Well Name: LIBERMAN	Well Location: T25N / R7W / SEC 5 / NWNW / 36.434174 / -107.603287	County or Parish/State: RIO ARRIBA / NM
Well Number: 3	Type of Well: CONVENTIONAL GAS WELL	Allottee or Tribe Name:
Lease Number: NMNM011639	Unit or CA Name:	Unit or CA Number:
US Well Number: 3003906191	Operator: KIMBELL OIL COMPANY

Notice of Intent

Sundry ID: 2756267

Well: Liberman 3

BLM FLUID MINERALS P&A Geologic Report

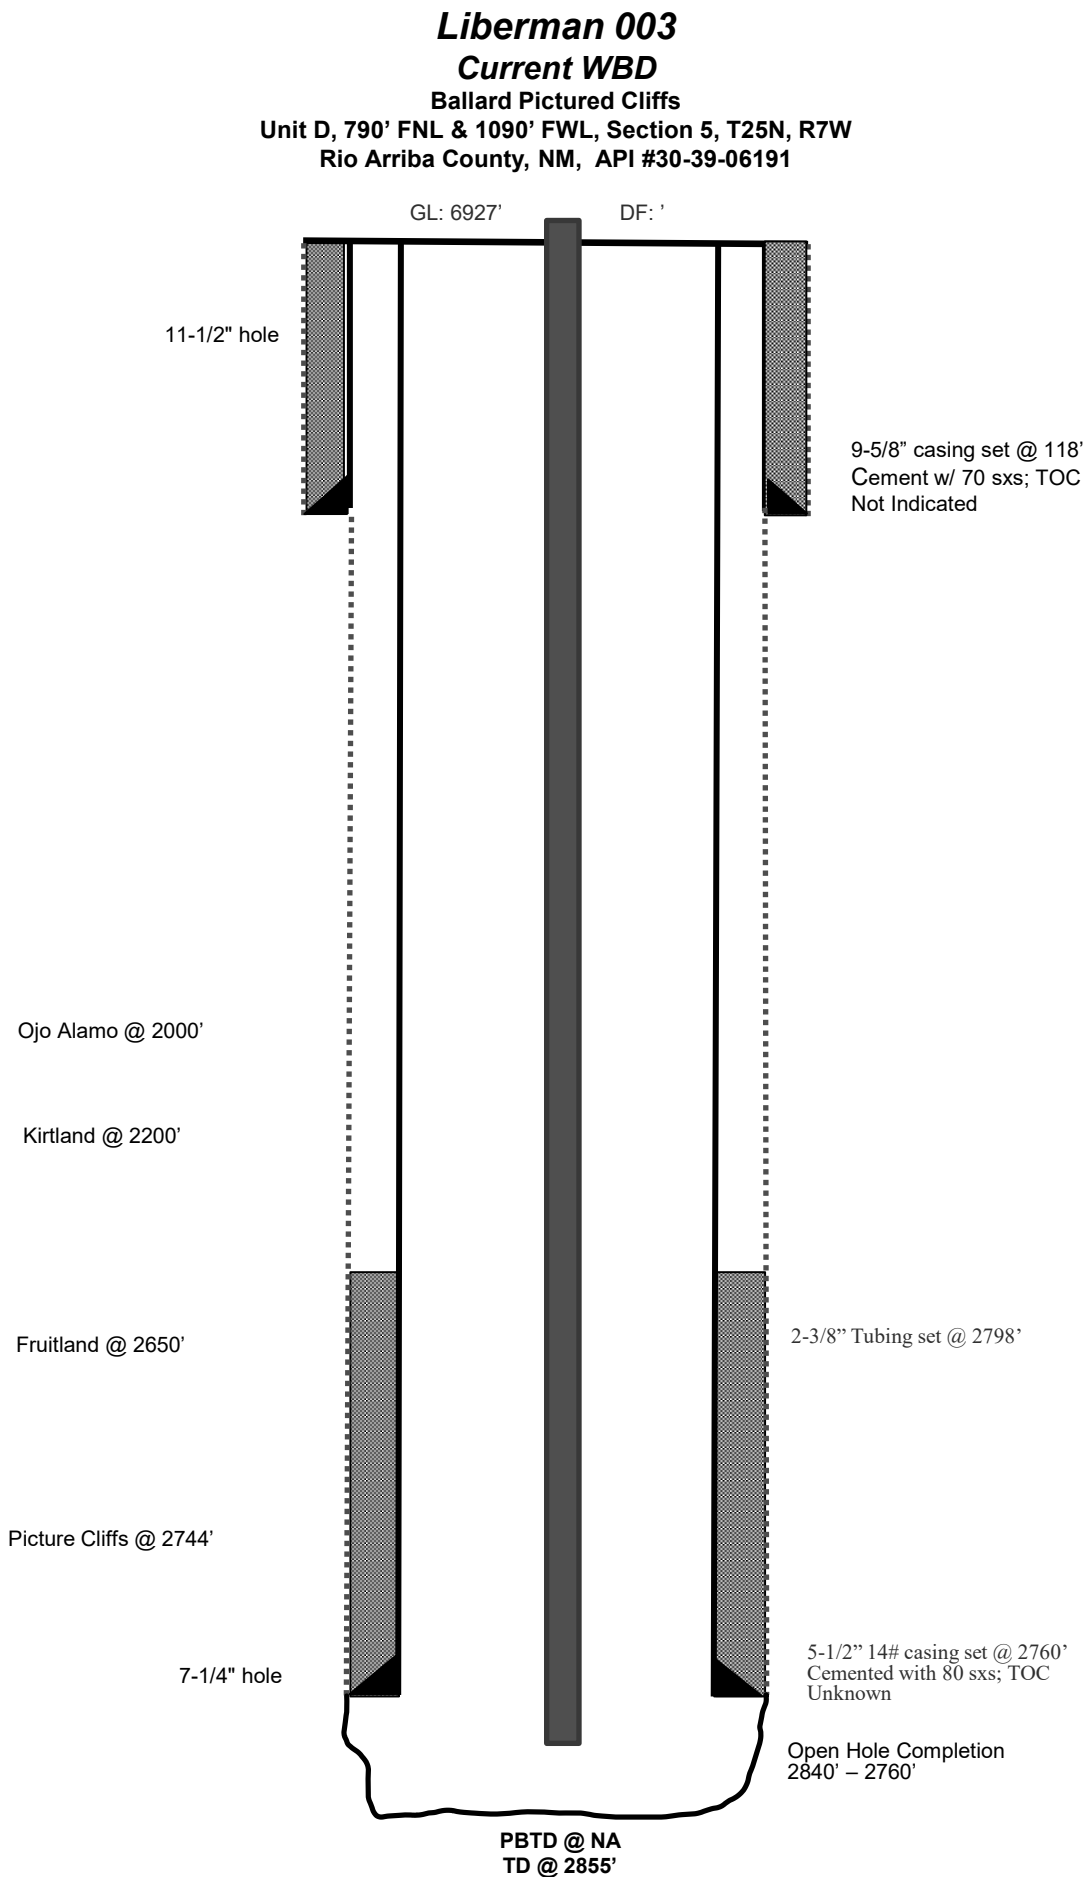
- Only raster logs available are from the reference wells that are close by. These logs agree with the estimated formation tops by the operator. Comparable because of the close approximately.
- These raster logs indicate the Nacimiento to be located at 950'. An inside/outside plug should be attempted at this location for the Liberman 3, depending on results of the CBL. Contact the BLM Farmington Field Office if cement cannot be placed outside of the casing.

Liberman 003
Current WBD
 Ballard Pictured Cliffs
 Unit D, 790' FNL & 1090' FWL, Section 5, T25N, R7W
 Rio Arriba County, NM, API #30-39-06191

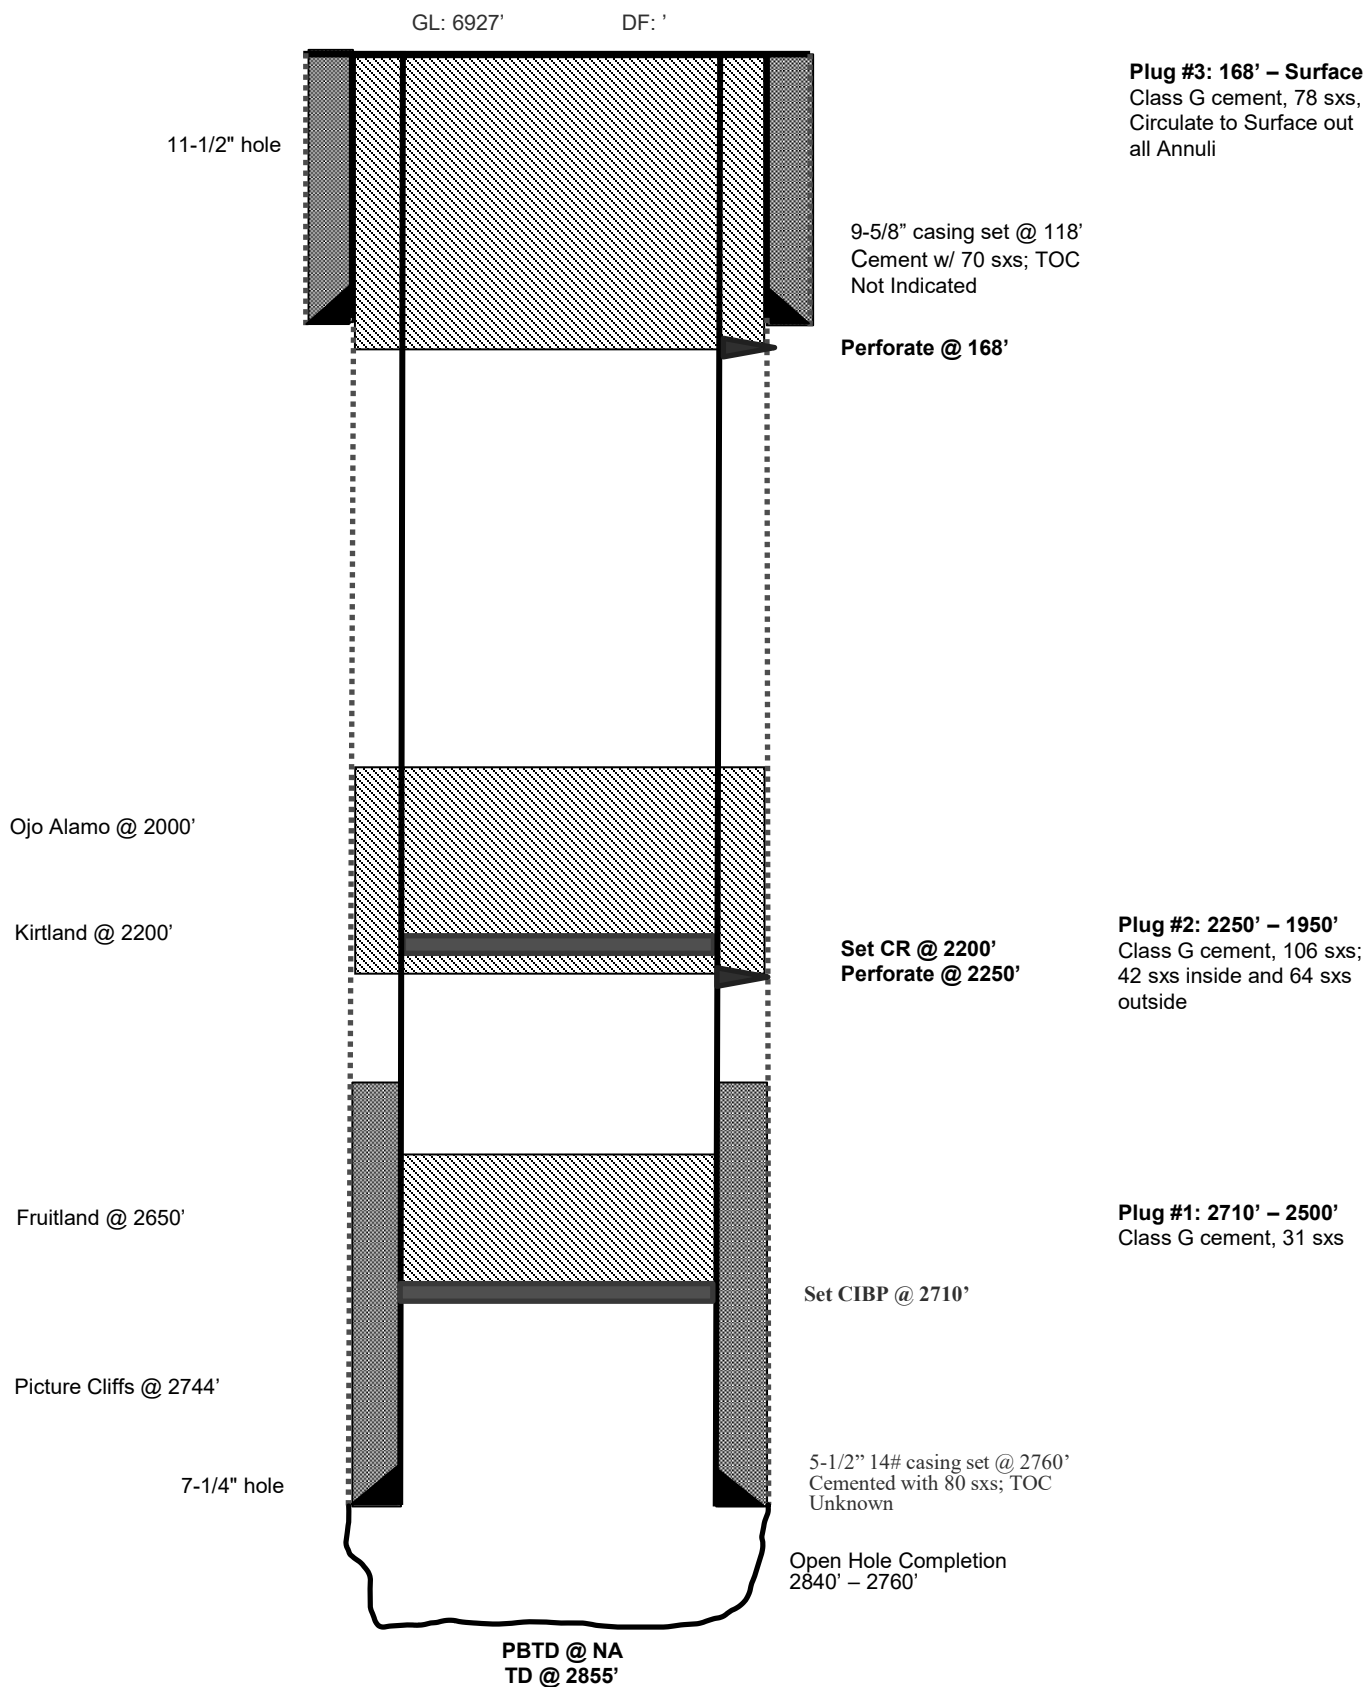
Created By	Condition	Condition Date
mkuehling	Add plug to open hole a plug of 50 feet below production casing shoe and 50 feet above shoe of production casing minimum - this plug required to be tagged - then proceed with plugging plan - NMOCD agrees with BLM call on formation tops - Notify NMOCD 24 hours prior to moving on - Monitor string pressures daily report on subsequent - Submit all logs prior to subsequent - Cannot combine plugs if pressure on the bradenhead without prior approval	7/11/2024
